## **R01EM**

## **RECALL R01EM**

### **INSTRUCTIONS FOR SLACK ADJUSTERS INSPECTION/CORRECTION AND REPLACING U-BOLT BRACKETS ON REAR AXLE**

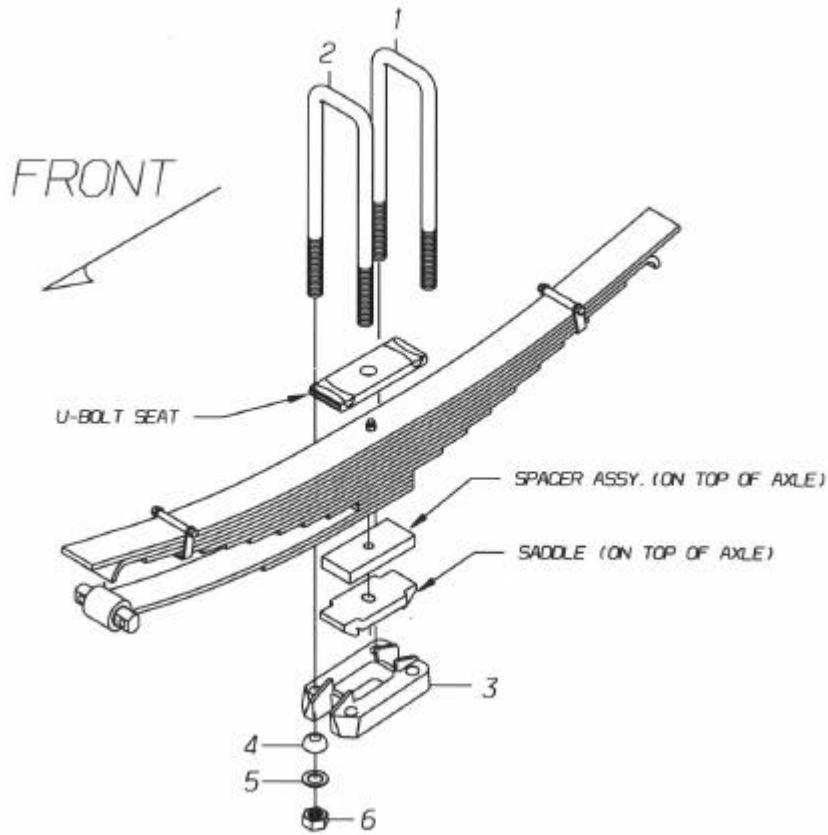
The defect involves the Crewson Brunner slack adjuster contacting the u-bolt bracket when bus is equipped with combination of components listed above.

Blue Bird Body Company's evaluation of the risk to motor vehicle safety is contact of the slack adjuster against the u-bolt bracket does not allow for full rotation of slack adjuster when brakes are applied with potential for reduced braking effort.

1. With wheels chocked, build air pressure in the brake system until maximum, then release parking brake and check slack setup.
2. Crewson Brunner slacks have a stroke indicator that is mounted to the automatic slack adjuster. This indicator shows both the correct setup position and the air chamber stroke. With the slack adjuster setup correctly, the yellow pointer will be in the area marked "HOME" (White area). If the Crewson Brunner is setup incorrectly, the setup must be corrected by following the attached information from Crewson Brunner.

NOTE: A template is required for correcting clevis location and one template will be supplied to distributor or customer.

1. Remove u-bolt nuts (Item 6), hardened flat washers (Item 5) and spherical washers (Item 4) in Illustration 1. Note: On units with options for shock absorbers and/or stabilizers bars, support these brackets while removing these fasteners. Discard nuts (Item 6) and flat washers (Item 5). Retain spherical washers (Item 4) and other brackets that may be removed.

2. Remove u-bolt bracket (Item 3) and u-bolts (Item 1 and Item 2). DO NOT remove saddle, spacer assembly or u-bolt seat as shown in Illustration 1. Discard u-bolt bracket (Item 3) and u-bolts (Item 1 and Item 2). If the u-bolt seat moves out of position, re-install before installing new u-bolts.

3. Install new u-bolts (Items 1 and Item 2) per chart on Illustration 1.
4. Install new u-bolt bracket (Item 3) oriented with notched (slope) toward front of bus as shown in Illustration 1. Install spherical washers (Item 4) removed from step 1 above. If shock absorber brackets and/or stabilizer bar brackets were removed in Step 1, re-install these components.

5. Install new hardened flat washers (Item 5) and new nuts (Item 6) onto the u-bolts. Torque nuts to 300-350 FT.LBS. To prevent distortion of u-bolts, tighten alternately.
